## Immediate Action Required User Safety Notice SN070523

3M™ Scott™ Air-Pak™ Wireframe, Air-Pak™ 75, Air-Pak™ NxG7 (Upgraded), Air-Pak™ X3 SCBA and Spare Assemblies

Figure 1

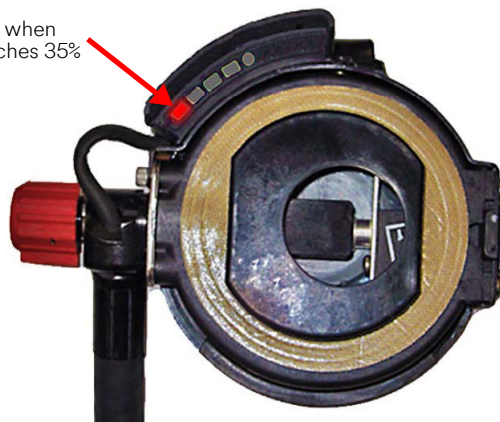
3M™ Scott™ Fire & Safety has received a small number of reports of Air-Pak 75, Air-Pak NxG7 (upgraded), Air-Pak X3 SCBA and spare consoles that were shipped with incorrect programming of the Heads-Up Display (HUD) secondary EoSTI. In the reported cases, although the Vibralert primary EoSTI will alarm at 35% of cylinder pressure in accordance with regulatory requirements, the HUD console lights will only indicate low air (red flashing light as illustrated in **Figure 1**) when the cylinder pressure reaches 25%. While both signals are measuring accurately, the HUD lights for these SCBA editions should be illuminating at 35%.

Red light should flash when  
cylinder pressure reaches 35%

If you identify one or more consoles within the date range, please remove the SCBA from service and contact your 3M Scott Authorized Service Center (ASC) to complete the repairs required.
